**ADDENDUM #2**

<b>Project</b>	TA Blakelock High School Renovations	<b>Project No.</b>	2215-C
<b>Location</b>	1160 Rebecca Street, Oakville, ON	<b>Date of Issue</b>	2025 04 25
<b>Owner</b>	Halton District School Board	<b>File</b>	2215/7.1.3

This Addendum forms part of the Contract Documents and amends the original Drawings and Specifications, dated 2025 04 17, and all preceding Addenda, as noted below.

3 FLOOR FINISH PLAN  
A101 1:50

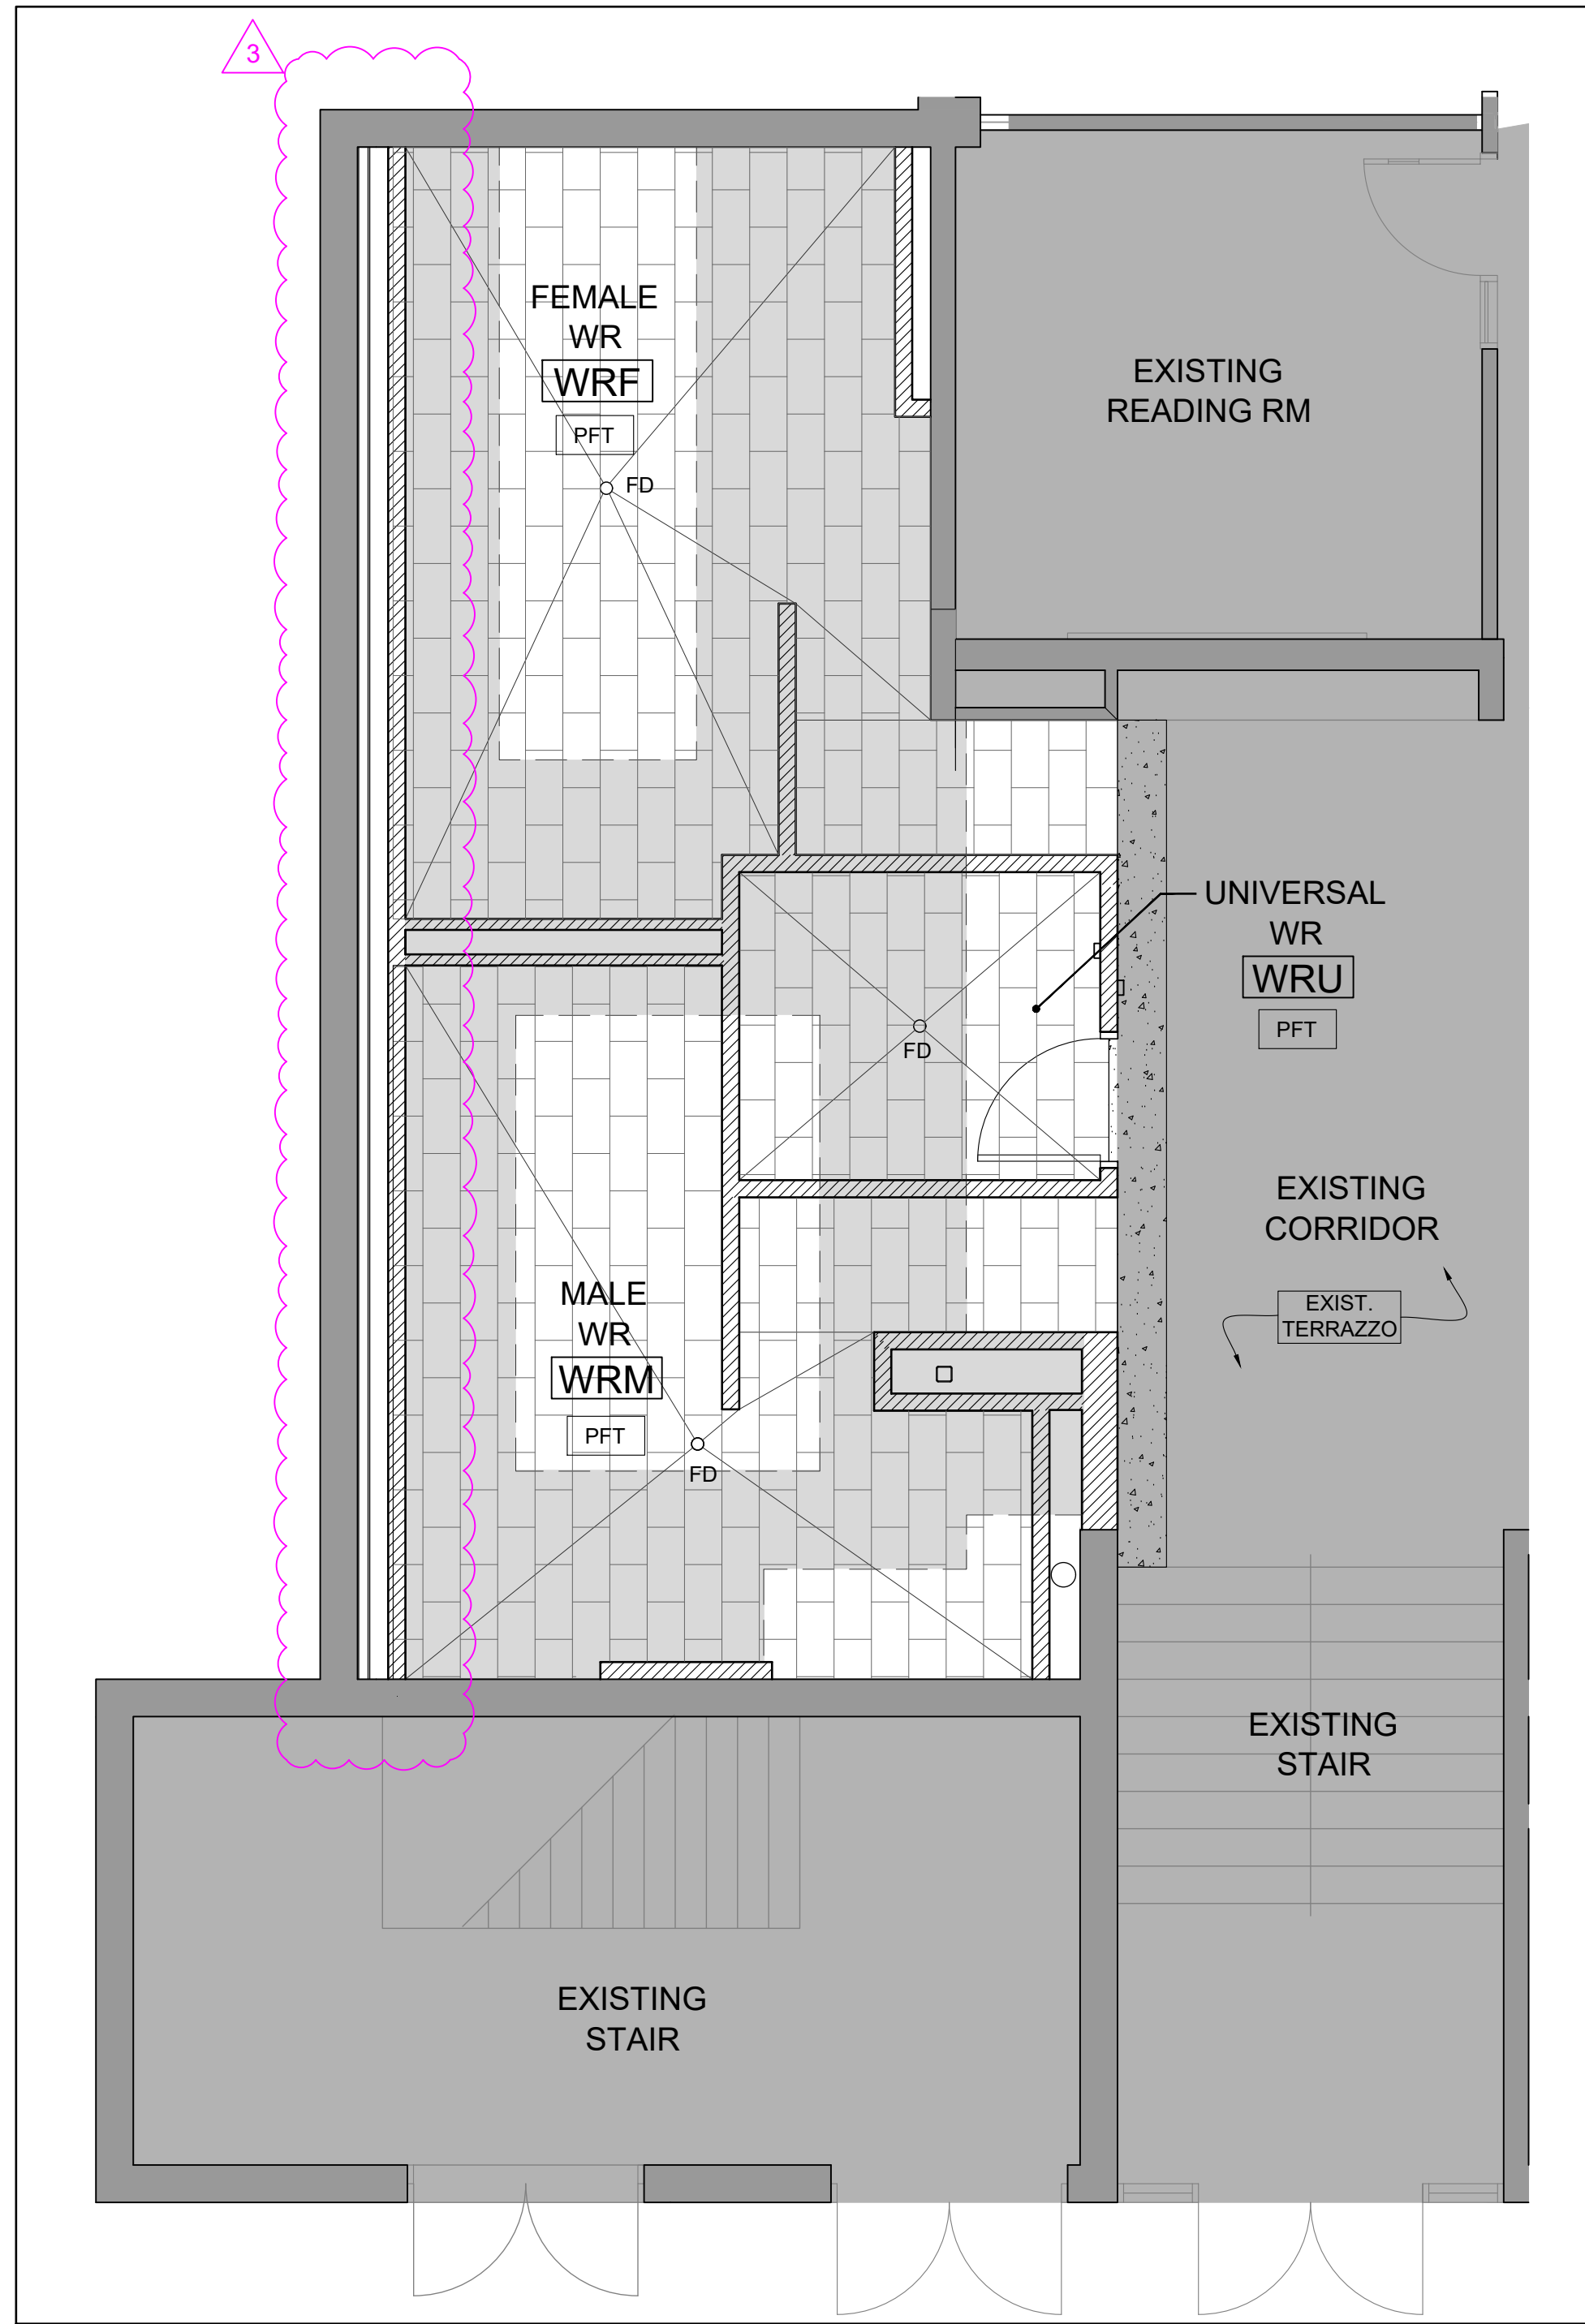
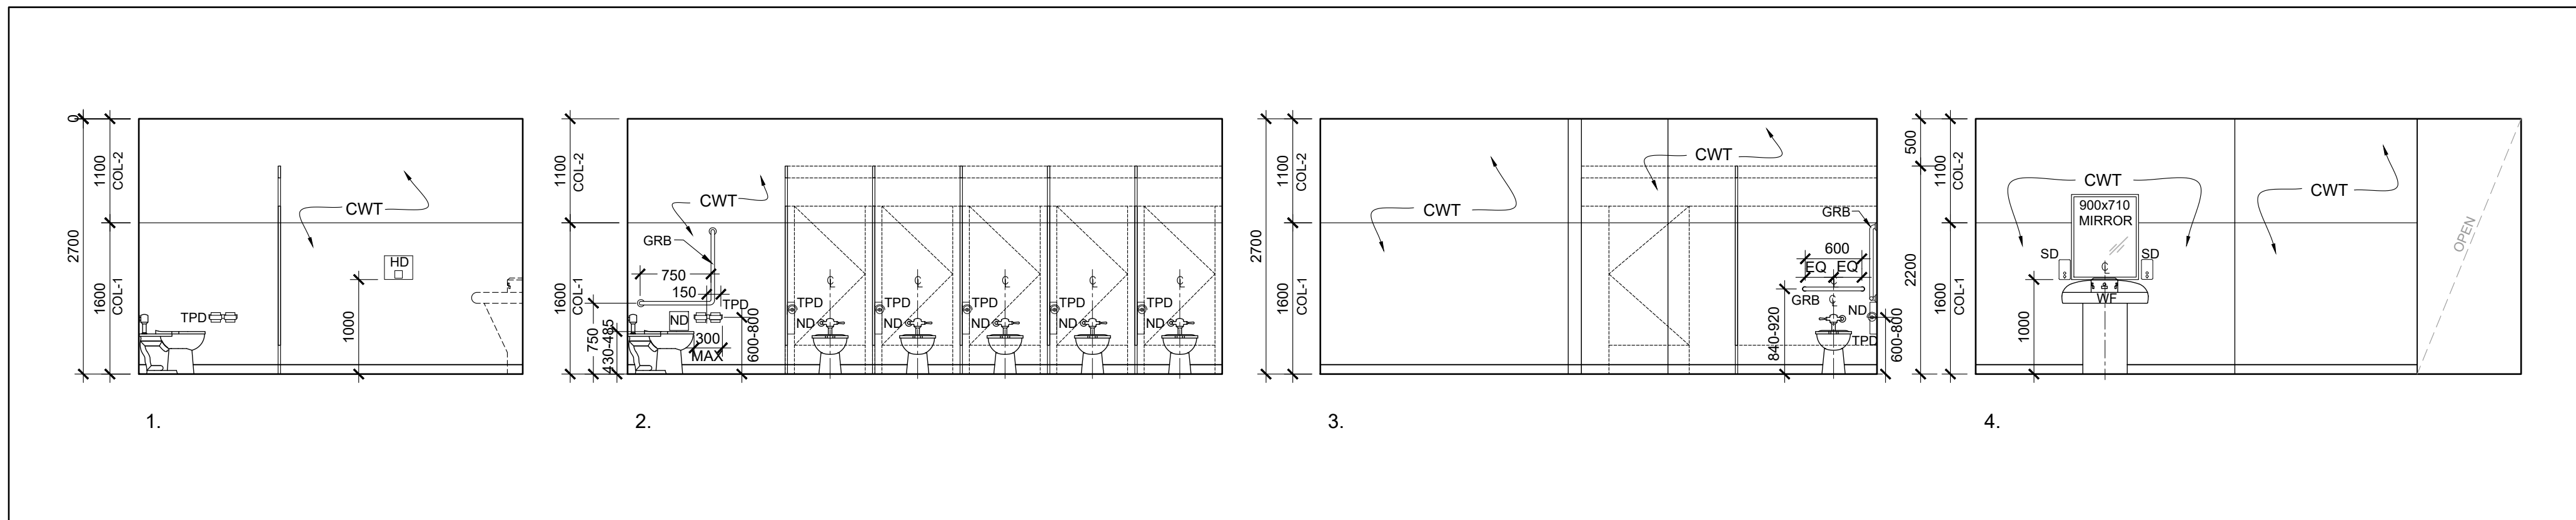
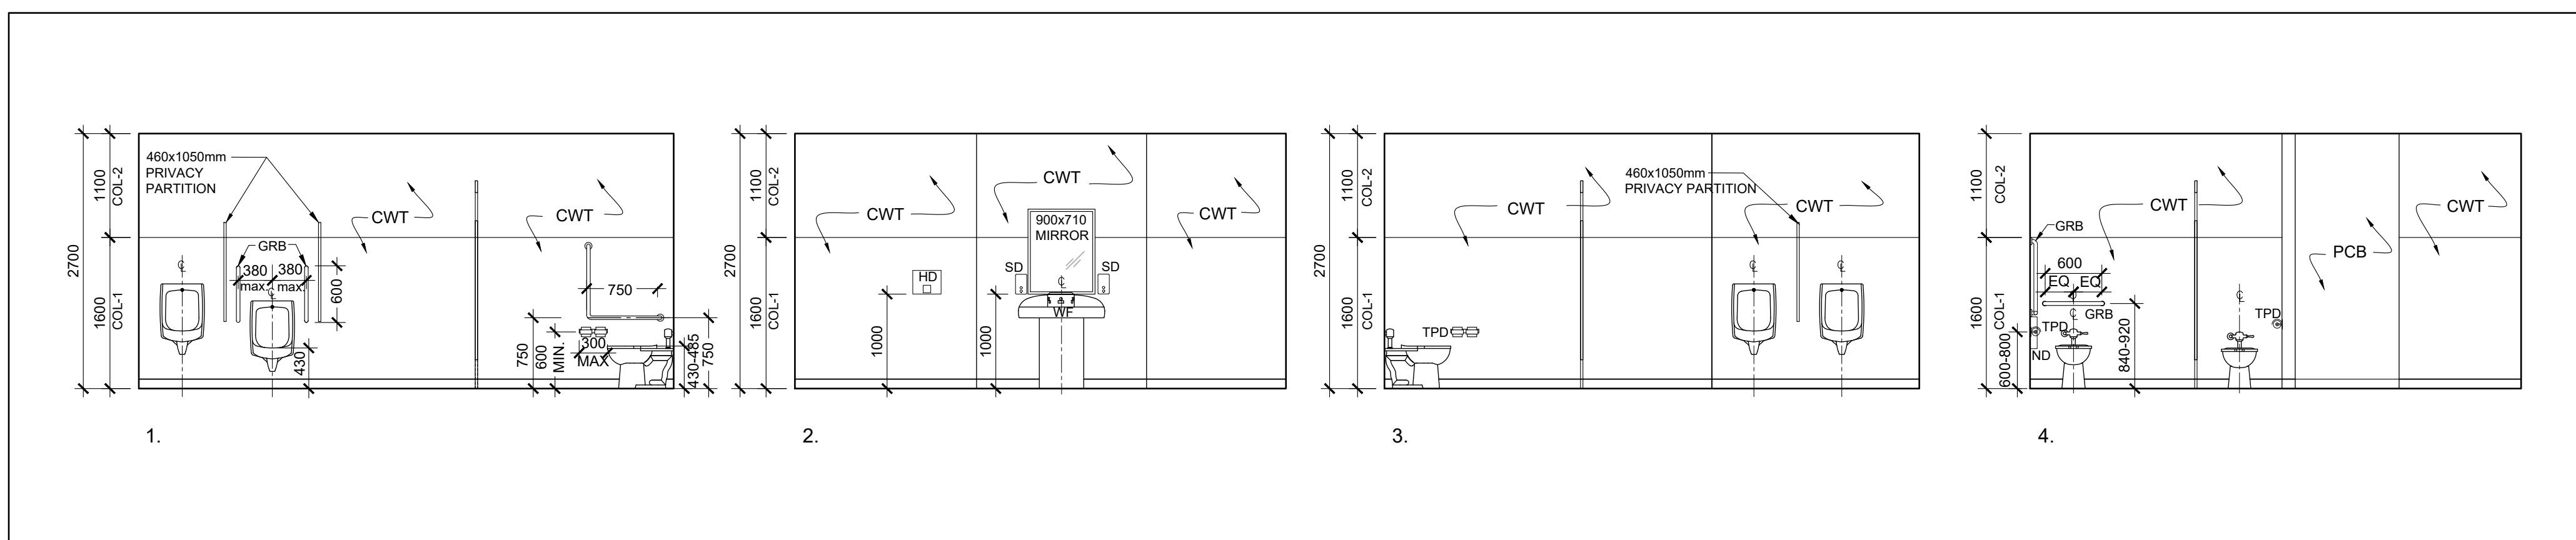
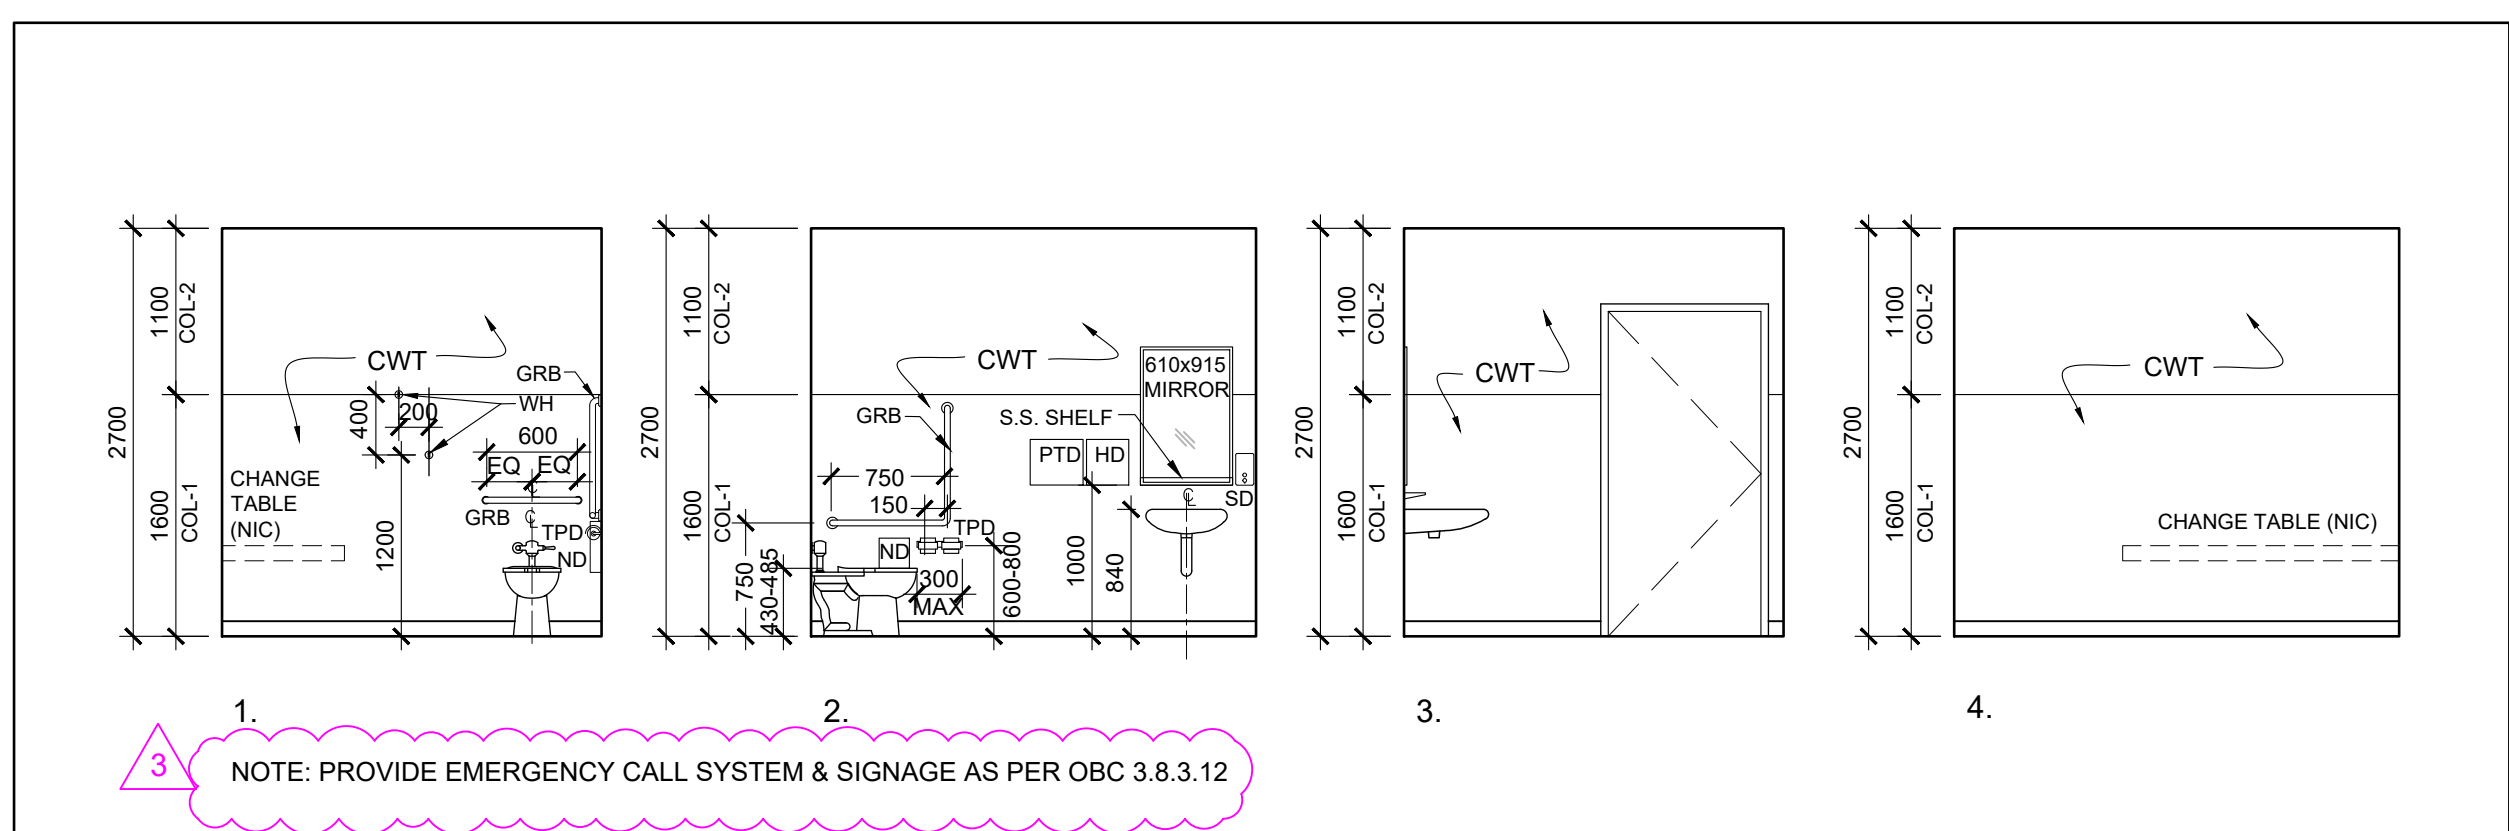
- .1 Interior plumbing wall was shifted to add insulation on the inside of the existing exterior wall.
- .2 Additional notes were added.
- .3 Washroom Accessories Schedule was added to the drawing.
